COMMUNITY DEVELOPMENT AGENCY  
ENVIRONMENTAL HEALTH SERVICES

RE: Pre-Application Conceptual Design Review for 44 Sylvan Way, Woodacre, CA, APN 172-252-03

**Subject:** 44 Sylvan Way, Woodacre, California; APN 172-252-03

Subject: Septic System Suitability Evaluation for Property at 44 Sylvan Way, Woodacre, California APN# 172-252-03

FIGURE  
1

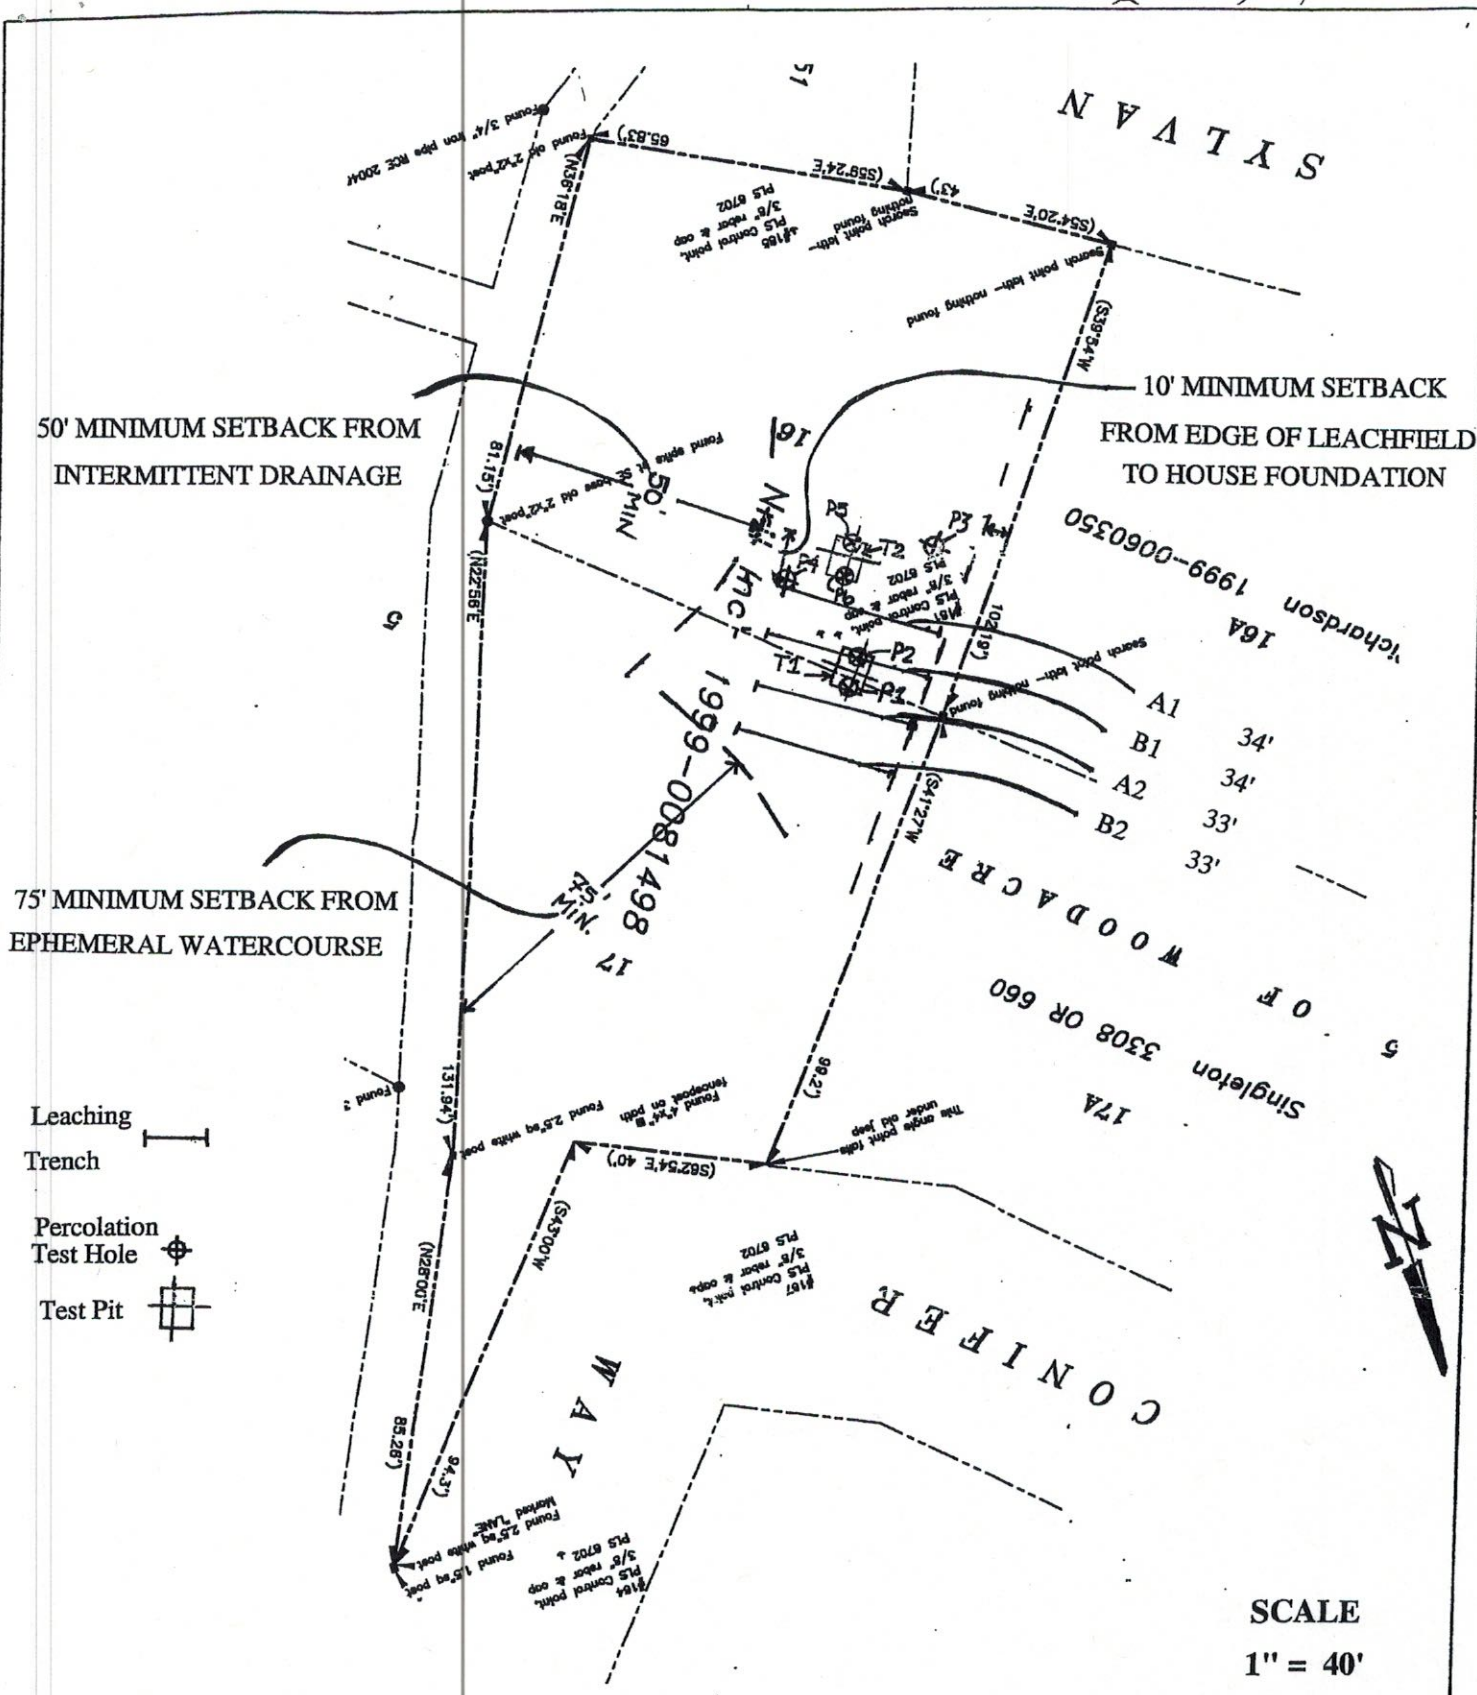
The site investigation included soil profile inspection, groundwater determination and percolation testing within the parcel. Based on the site investigation we recommend that the septic system be located along the western section of the lot in an area 70-feet long by 40-feet wide (see **Figure 1**). The proposed design would incorporate pressure-dosed leaching trenches. The test results and design recommendations are as follows.

The slopes on the lot are greater than 60 percent. The property is accessible from Sylvan and Conifer Way. The section of the parcel, 75 feet from the ephemeral watercourse and 50 feet from the intermittent drainage and southeastern property line, is the area which has suitable soils and percolation rates (**Note:** Marin County Regulations require 75-foot leachfield setback from a ephemeral watercourse and 50-foot setback from intermittent drainage).

50' MINIMUM SETBACK FROM  
INTERMITTENT DRAINAGE

75' MINIMUM SETBACK FROM  
EPHEMERAL WATERCOURSE
